**US Army Corps
of Engineers**

**BRADFORD ISLAND
FISHWAY MODIFICATION EDR
FINAL SUBMITTAL**

CONTRACT NO. W9127N-11-D-0009
WORK ORDER No. 5

August 2012

Figure 2.1 Bradford Island Fishway

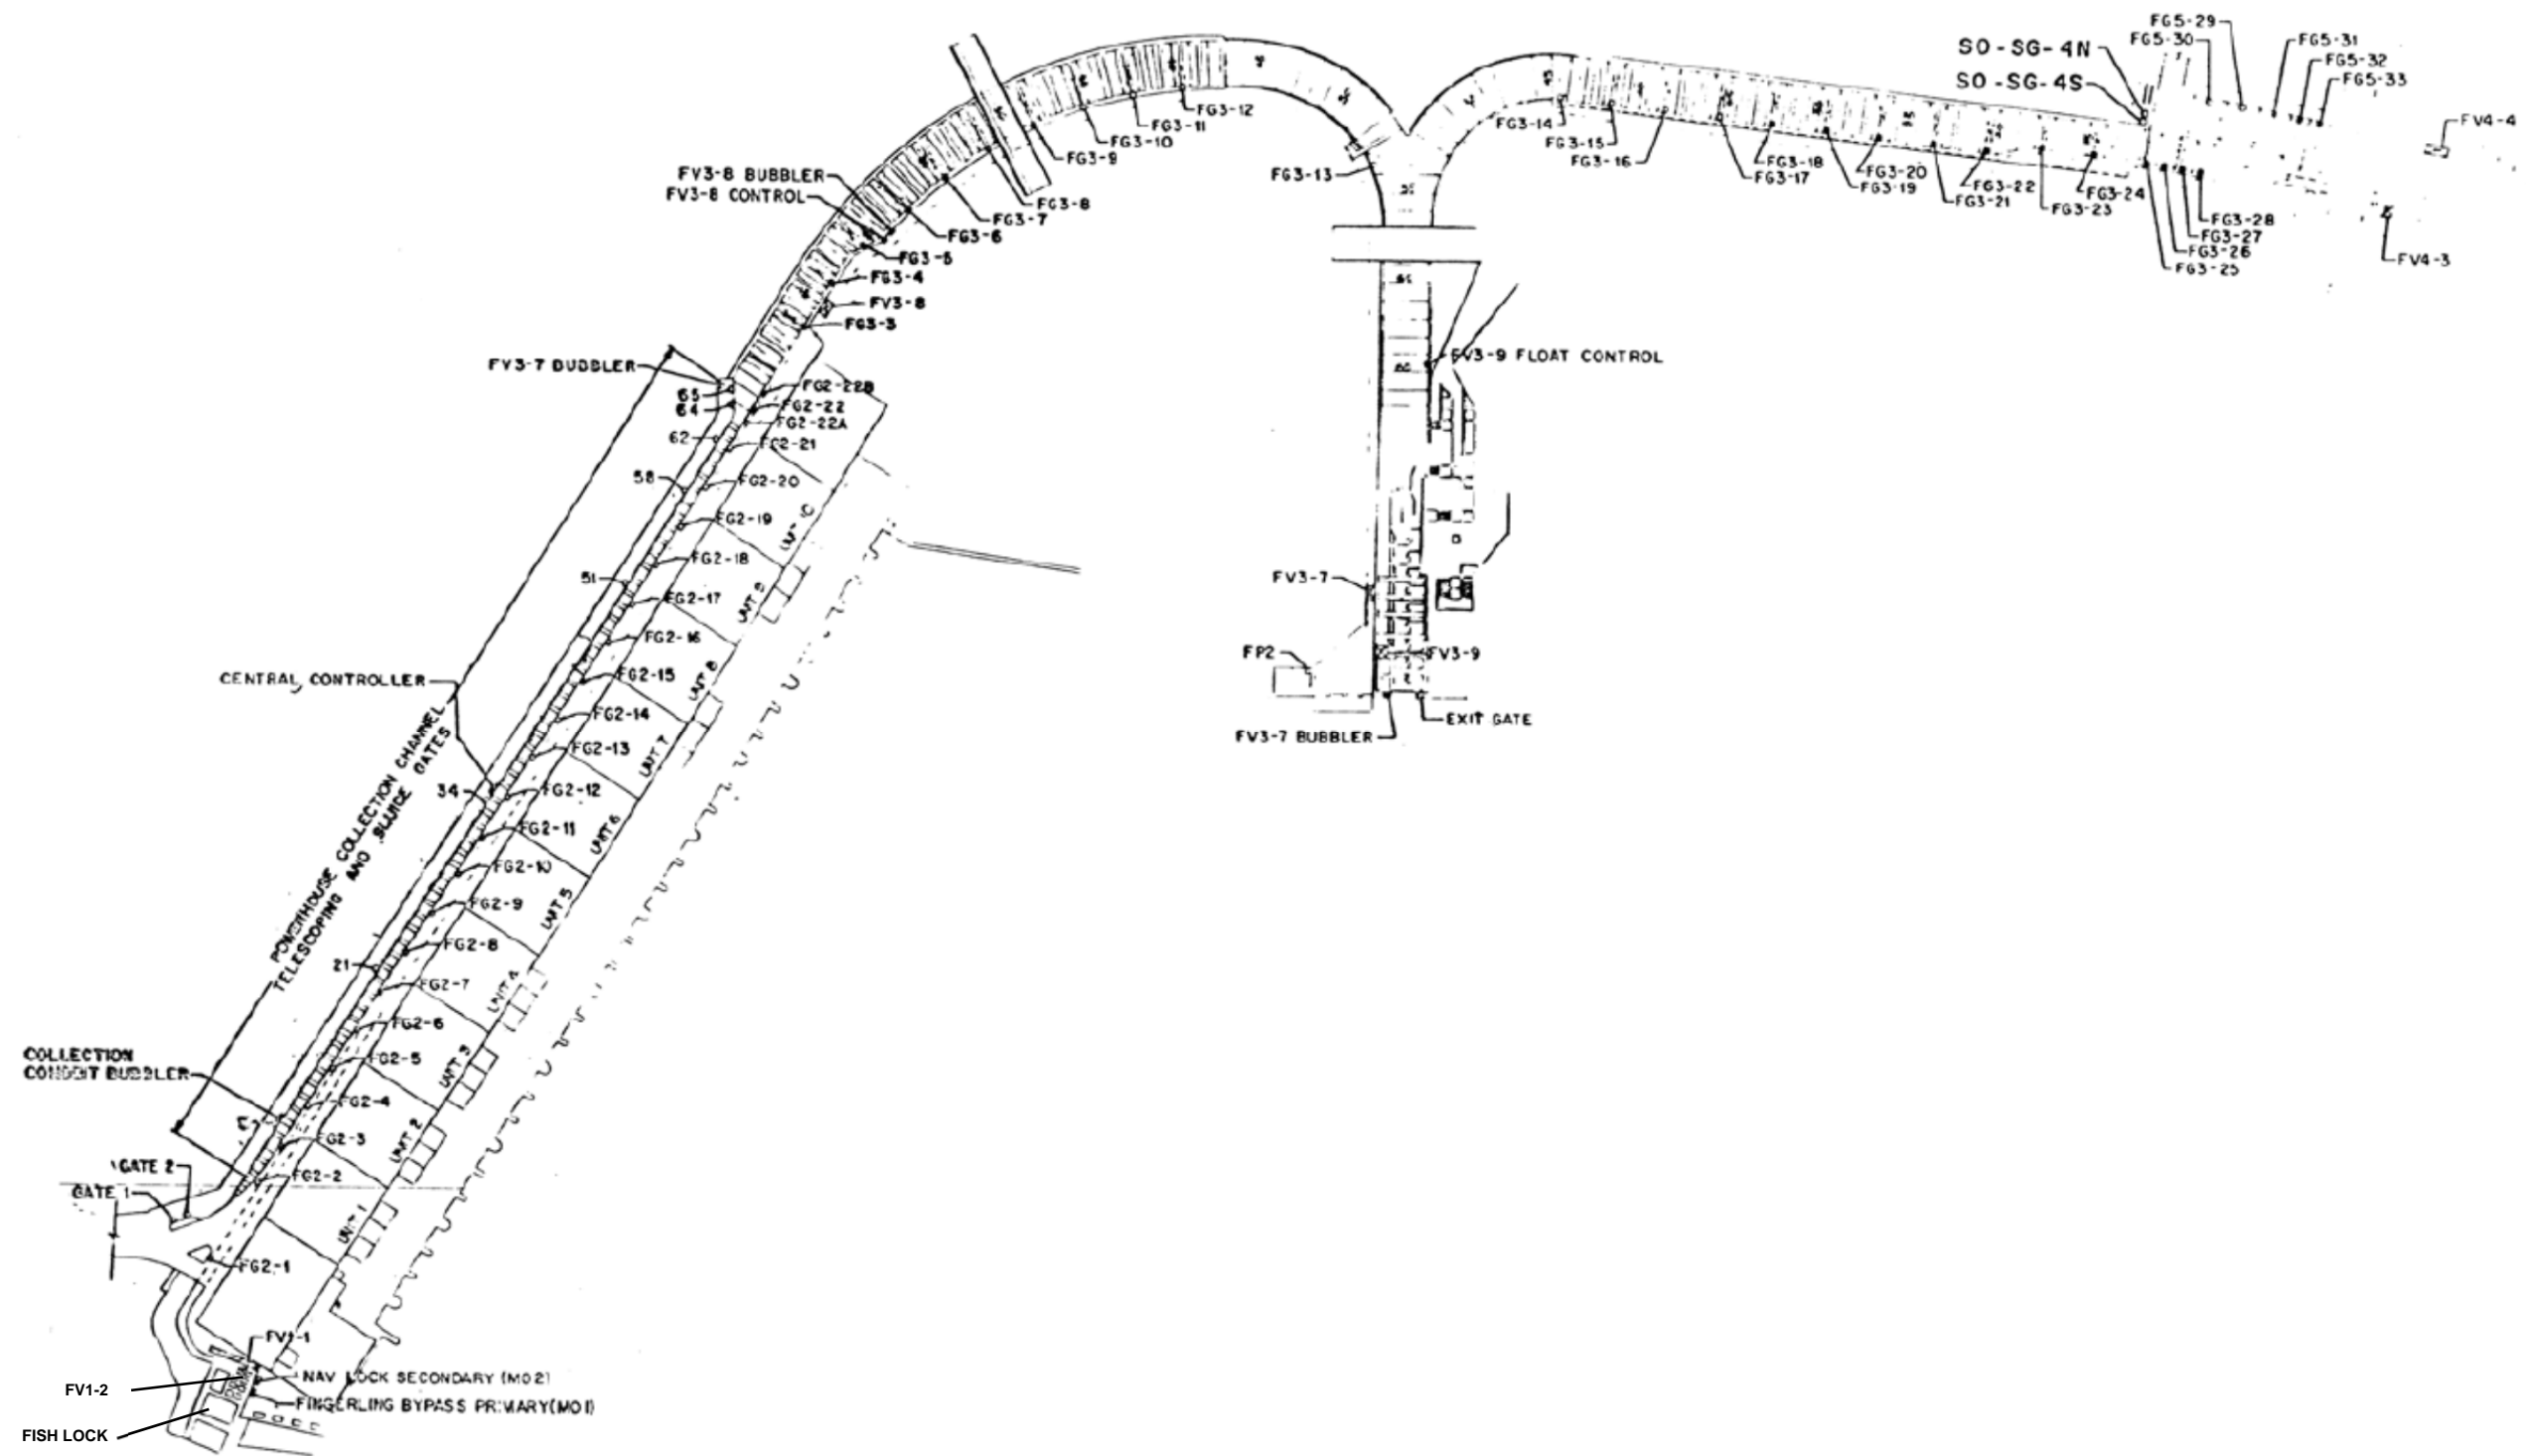
4716163	General	n/a'	Pg 2-4	n/a
In section 2.3 Fish Passage Components, there are a number of features that should be identified on Figures 2.1, 2.2 and 2.3 in order to let the readers know where these features are located in the ladder systems Should be similar coverage of features as on Figure 3.1 . For instance I didn't see the Fish Lock on any of the various figures but I think that those not real familiar with Bonneville will need to know where these features are located. Submitted By: Mike Crump (503-808-4946). Submitted On: 10-Jul-12				
1-0	Evaluation Concurred Corrected Submitted By: Eric Flickinger (425-635-1000) Submitted On: 20-Jul-12

1-0	Evaluation Concurred Figure 2.1 has been moved to section 1. Figure references have been fixed. Submitted By: Eric Flickinger (425-635-1000) Submitted On: 30-Jul-12			
1-1	Backcheck Recommendation Close Comment Closed without comment. Submitted By: Elizabeth Roy (503-808-4849) Submitted On: 09-Aug-12			
Current Comment Status: Comment Closed				
4737433	Hydraulics	n/a	n/a	n/a
Section 1.2. Suggest moving the reference to Figure 2.1 up to Section 1.2 to hit it sooner. Also in Section 2.1, second sentence, suggest "It also comprises one half of the Bradford Island system, which includes B Branch as shown in Figure 2.1" (but this would be the image that is currently in Fig 2.2).				
Submitted By: Elizabeth Roy (503-808-4849). Submitted On: 20-Jul-12				
1-0	Evaluation Concurred See comment 4737432 Submitted By: Eric Flickinger (425-635-1000) Submitted On: 26-Jul-12			
1-1	Backcheck Recommendation Close Comment Closed without comment. Submitted By: Elizabeth Roy (503-808-4849) Submitted On: 09-Aug-12

Figure 2.2 Bradford Island A Branch Diffusers

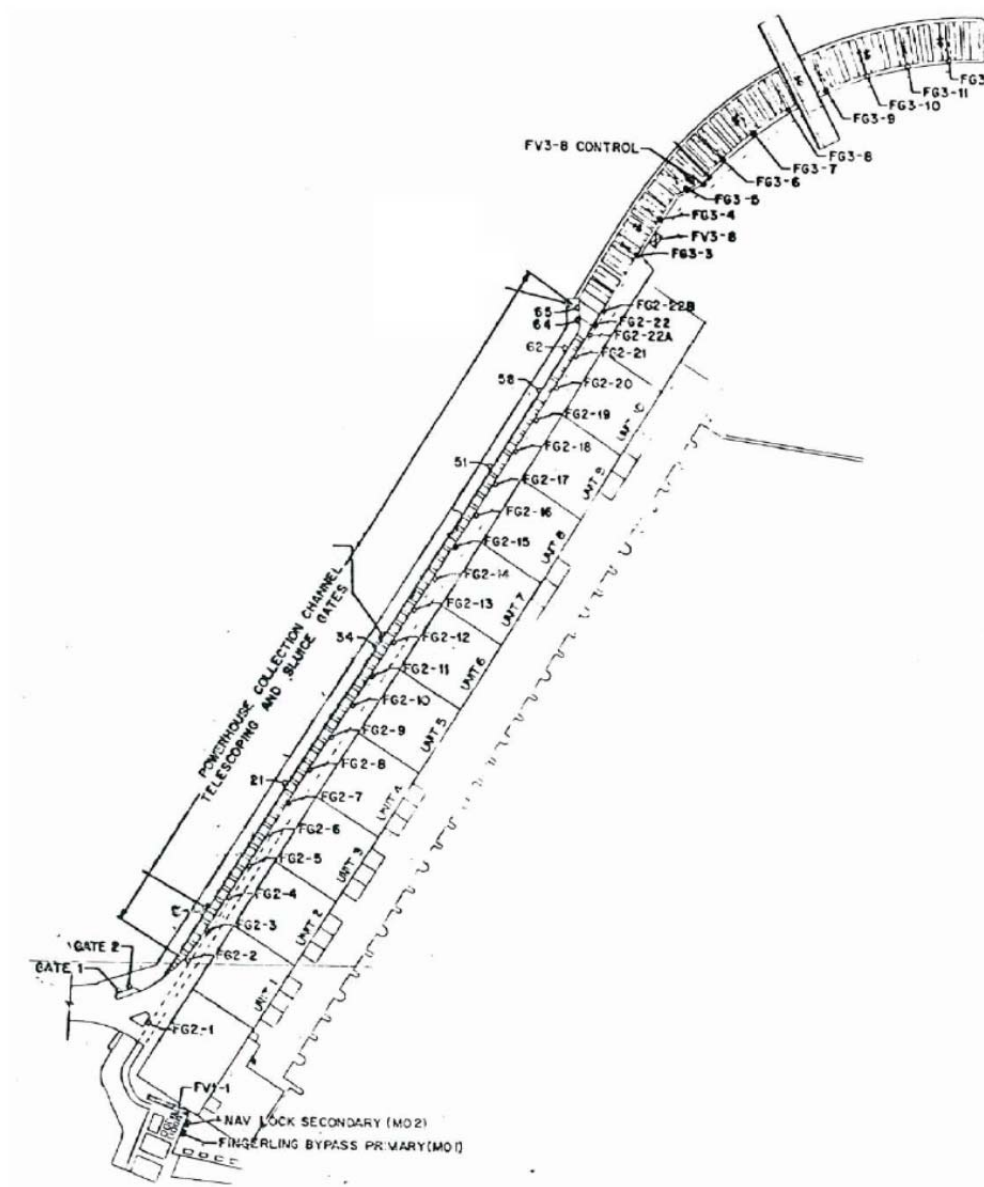
Figures 2.1 and 2.2 provide a good overview of the project, but don't clearly show all features described in the text and rated in the decision matrix (Figure 2.2 is too small and blurry to see diffuser numbers, valve locations, etc., etc., etc.)

(Document Reference: [Figure 2.2](#))

The north entrances to the A Branch are WG-64 and WG-65, not WG-63 and WG-64 as labeled in Figure 2.2

1-0	Evaluation Concurred FV3-7 is shown on Figure 2.2 and 3.1. FV1-2 is added to Figure 2.3 Submitted By: Eric Flickinger (425-635-1000) Submitted On: 20-Jul-12			
1-1	Backcheck Recommendation Close Comment Closed without comment. Submitted By: Mike Crump (503-808-4946) Submitted On: 06-Aug-12			
	Current Comment Status: Comment Closed			
4716169	General	n/a'	Pages 5-9 to 5-11, pages 6-6 and 6-7	n/a
Within these pages there are statements regarding grating replacement. Will these grating need to be replaced with lamprey friendly grating that have narrower clear spaces between the bearing bars ? Probably need to have comment regarding hydraulic flow checks for narrower bar gaps. Submitted By: Mike Crump (503-808-4946). Submitted On: 10-Jul-12				
1-0	Evaluation Concurred See response to comment 4706944 Submitted By: Eric Flickinger (425-635-1000) Submitted On: 20-Jul-12			
1-1	Backcheck Recommendation Close Comment Closed without comment. Submitted By: Mike Crump (503-808-4946) Submitted On: 06-Aug-12

Figure 3.1 Bradford Island B Branch Diffusers and Fish Exit Section.

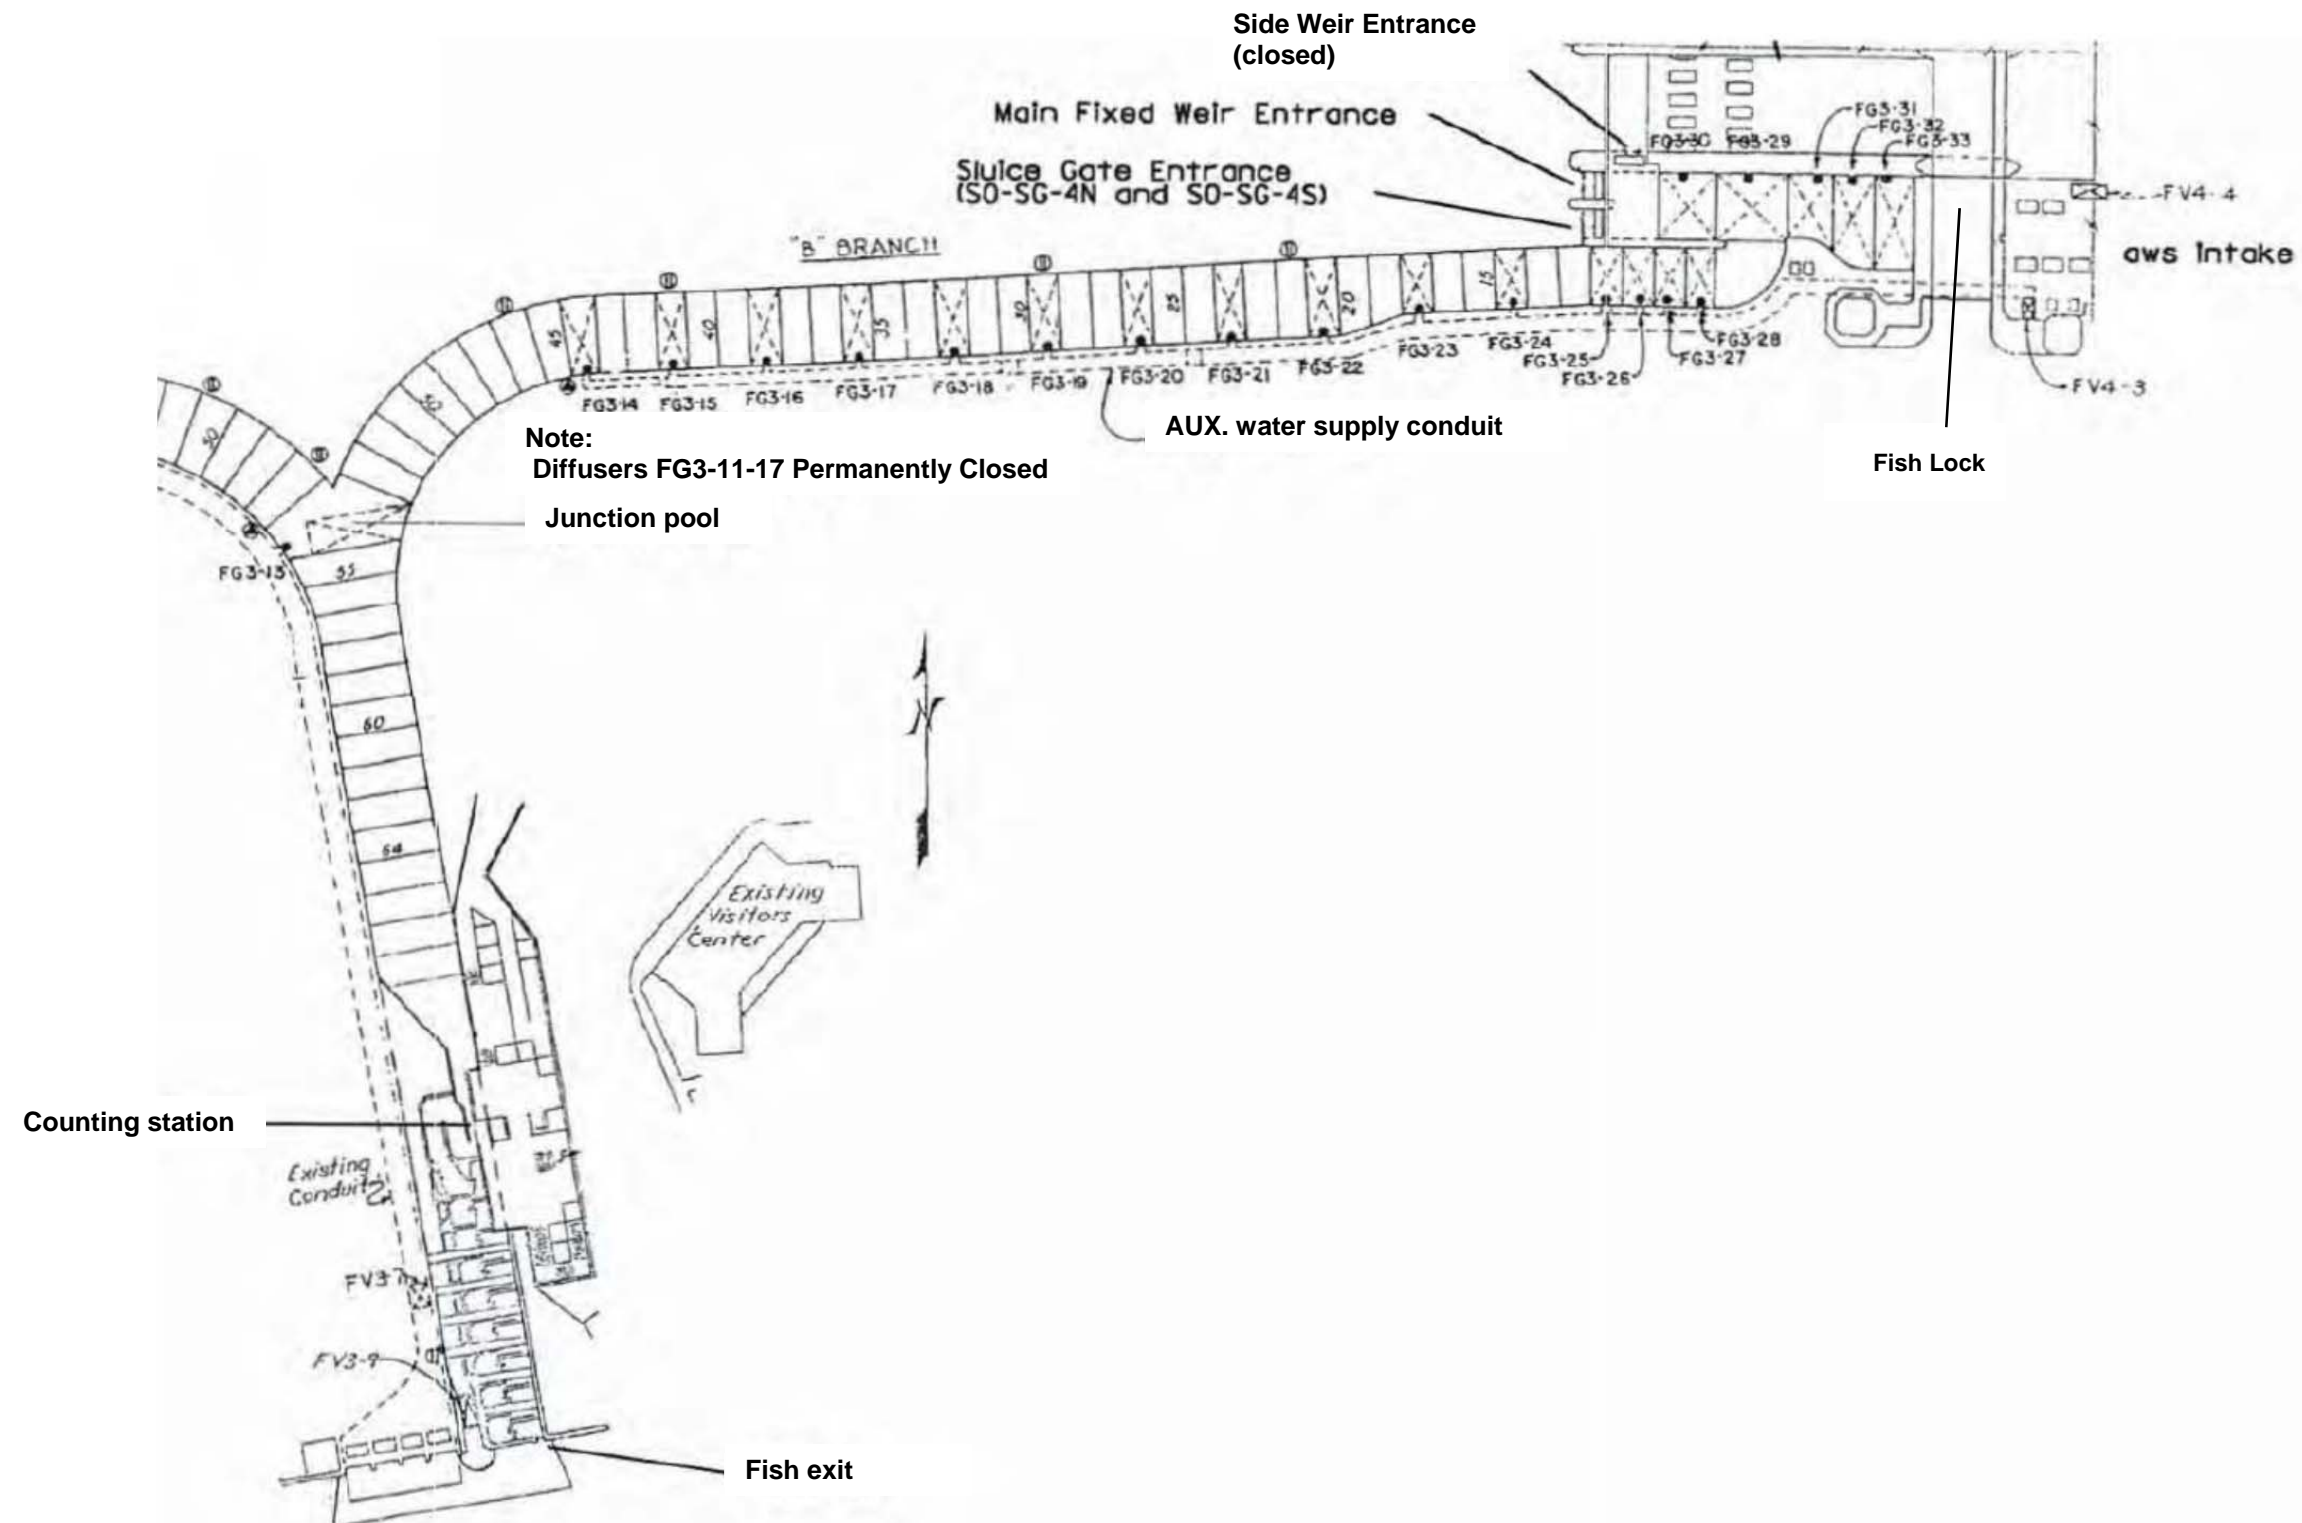
Current Comment Status: Comment Closed				
4737434	Hydraulics	n/a	n/a	n/a
Section 3.1. I am not sure if Figure 3.1 has a figure reference in the text. Please check and if not, reference it in Section 3.1.
